# SERVICE BULLETIN

**Service Bulletin No.:** DA20-28-01 Rev 0  
**Title:** Fuel Cap, Safety Chain

**Date Issued:** August. 26, 1996  
**Page:** 1 of 3

FIGURE 1.

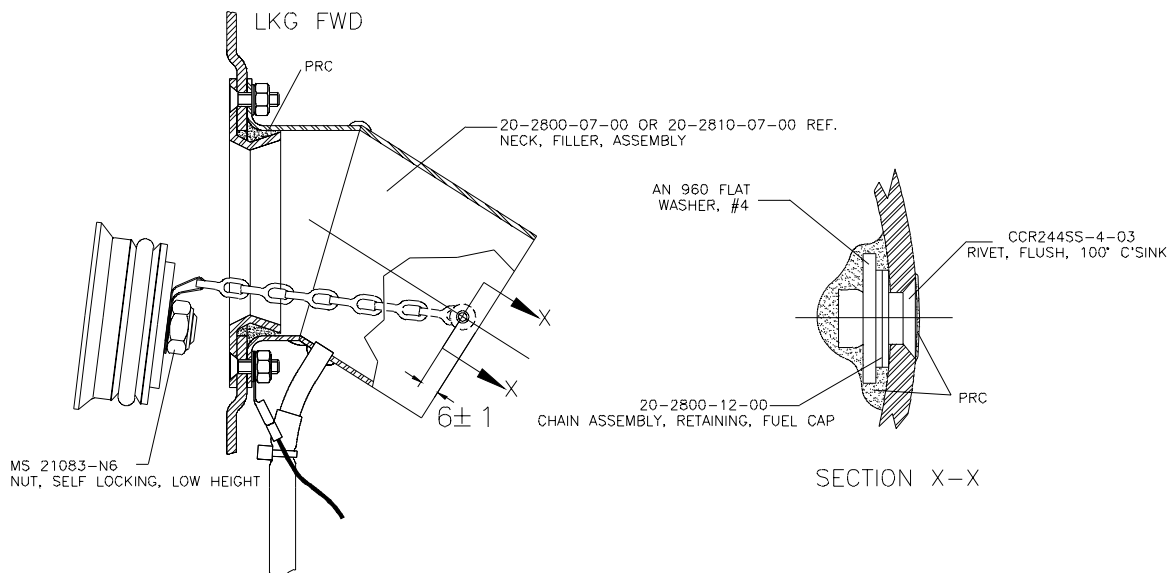
**3. General:** The existing Fuel Filler Cap (P/N UD-3F) requires frequent lubrication of the O-ring seal, under high usage conditions. Failure to lubricate the seal may cause loss of fuel cap security. This bulletin describes the installation of a fuel cap safety chain.

- ### 10.2. Filler Neck Modification:
- 10.2.1 On the aft side of the filler neck (i.e. closest to the B-Bulkhead) drill a .125" / .129" hole in the filler neck shown in Figure 1.
  - 10.2.2 Countersink the .125" / .129" hole so that the rivet will just sit flush to the filler neck O.D. Deburr the hole.

- 10.2.3 Rivet the chain assembly to the filler neck as shown in the section view.
- 10.3 Resealing the Installation:**
  - 10.3.1 Seal rivet with PRC fuel sealant inside and out as shown in section view.  
The coating on the filler neck O.D. should be spread flush.
  - 10.3.2 Ensure all grounding straps and vent tubes are properly installed and sealed per the maintenance manual.
  - 10.3.3 Re-install the filler hose apposite to 10.1.2.
  - 10.3.4 Attach fuel cap to chain tab and re-install nut. Nut is in safety when one thread is showing. Note: Inspect nut locking element. If it can be fully finger tightened replace. (ref AC 43.13 1A/2A)
  - 10.3.5 Lubricate fuel cap O-Ring (Fuelube or Vaseline is recommended) and install fuel cap.
  - 10.3.6 Re-install baggage floor
